Access Compliance Report

Public Rights-of-Way

Intersection ID: 30402	Main Street: WOODLAWN_RD	Cross Street: PARK_RD_SHOPPING_CENTER_DR	Location: NE
ADA ID: 32D49FCAEB74	Ramp Type: PerpDiag	Initial Pass/Fail: Fail	Overall Compliance: No
		Severity Score: 12.5

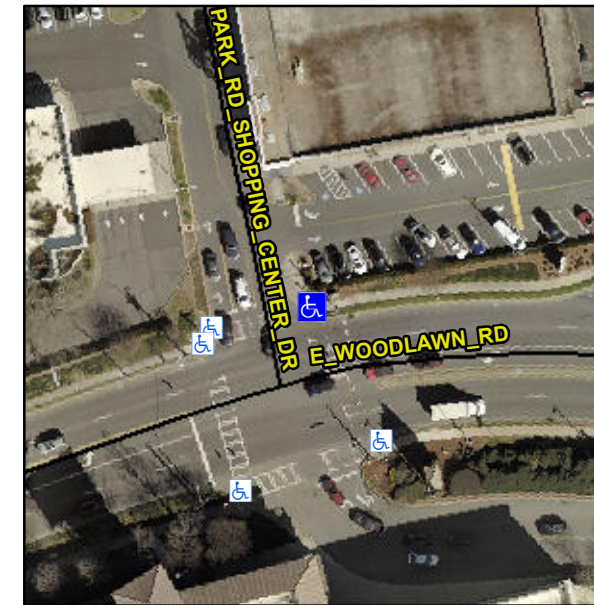
Compliance	Description	Data	Compliance	Description	Data
N/A	Ramp Length (in)	24.0	No	Ramp Slope (%)	8.5
Yes	Ramp Width (in)	48.0	Yes	Ramp XSlope (%)	1.2
N/A	Flare Type LT	N/A	N/A	Flare Type RT	N/A
N/A	Flare Slope LT (%)	N/A	N/A	Flare Slope RT (%)	N/A
N/A	Flare Traversable LT?	N/A	N/A	Flare Traversable RT?	N/A
N/A	Landing Length (in)	N/A	N/A	DWS Provided?	N/A
N/A	Landing Width (in)	N/A	N/A	DWS Contrast?	N/A
N/A	Landing Slope (%)	N/A	N/A	DWS Length (in)	N/A
N/A	Landing X Slope (%)	N/A	N/A	DWS Full Width?	N/A
N/A	Landing Curb? (Y/N)	N/A	N/A	DWS Offset (in)	N/A
N/A	Shared Landing?	N/A			
N/A	Gutter Ponding?	N/A	N/A	Gutter Slope (%)	N/A
N/A	Gutter Lip Ht (in)	N/A	N/A	Gutter X Slope (%)	N/A
N/A	Painted X Walk1?	Yes	N/A	Painted X Walk2?	Yes
	X Walk 1 Direction	To W		X Walk 2 Direction	To SE
N/A	X Walk 1 Width (in)	100.0	N/A	X Walk 2 Width (in)	100.0
	X Walk 1 Slope (%)	3.8		X Walk 2 Slope (%)	3.3
	X Walk 1 X Slope (%)	3.8		X Walk 2 X Slope (%)	3.5

Remove & Replace Curb Ramp With Two New Directional Ramps or Equivalent.

R304.2.2
